Access Compliance Report

Public Rights-of-Way

(Island Curb Cuts)

Intersection ID: 10037033	Main Street: S_TRYON_ST	Cross Street: N/A	Location:	W
ADA ID: 2BCBD790206A	Curb Cut Type: MedianRefuge2	Initial Pass/Fail: Pass	Overall Compliance: No	Severity Score: 0

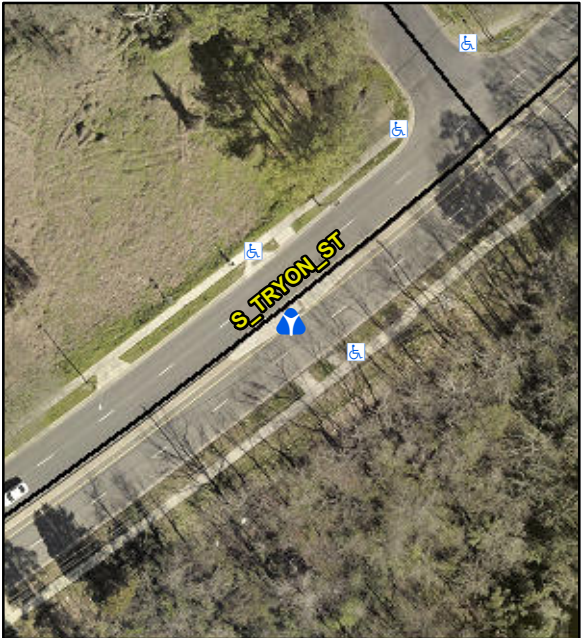
Codes/Mitigation Info/Possible Solution			Field Measurements/Component Compliance			
	Possible Solutions:		Compliance	Description	Data	
	Remove & Replace Gutter.		Yes	Refuge 1 Length (In)	48.0	N/A
			Yes	Refuge 1 Width (In)	96.0	N/A
			Yes	Refuge 1 Slope (%)	1.8	N/A
			Yes	Refuge 1 X Slope (%)	0.8	N/A
			N/A	Painted X Walk1?	No	Yes
			N/A	X Walk 1 Direction	To SE	Yes
			N/A	X Walk 1 Width (In)	N/A	Yes
			N/A	Road 1 Slope (%)	0.8	Yes
			N/A	Road 1 X Slope (%)	4.3	Yes
<p>Surveyor Notes:</p> <p>N/A</p>			Yes	Refuge 2 Length (In)	48.0	Yes
			Yes	Refuge 2 Width (In)	96.0	Yes
			Yes	Refuge 2 Slope (%)	1.4	No
			Yes	Refuge 2 X Slope (%)	0.2	No
			N/A	Painted X Walk2?	No	Yes
			N/A	X Walk 2 Direction	To NW	Yes
			N/A	X Walk 2 Width (In)	N/A	Yes
			N/A	Road 2 Slope (%)	0.3	Yes
			N/A	Road 2 X Slope (%)	3.7	Yes
			N/A	Refuge 3 Length (in)	N/A	N/A
<p>PROW/ADA:</p> <p>N/A</p>			N/A	Refuge 3 Width (in)	N/A	N/A
			N/A	Refuge 3 Slope (%)	N/A	N/A

N/A	Refuge 3 XSlope (%)	N/A	N/A
			N/A	Painted X Walk3?	N/A	N/A
			N/A	X Walk 3 Direction	N/A	N/A
			N/A	X Walk 3 Width (in)	N/A	N/A
			N/A	Road 3 Slope (%)	N/A	N/A
			N/A	Road 3 XSlope (%)	N/A	N/A
			Yes	Any Obstructions?	N/A	N/A
			N/A	Obstruction Type	N/A	N/A
<p>Total Cost:</p> <p>\$ 750.00</p>			N/A	Storm Grate/Utility Hazard?	No	N/A
			N/A	Storm Grate/Utility Type	N/A	N/A
			N/A		N/A	N/A
			N/A	Surface Condition	Good	N/A
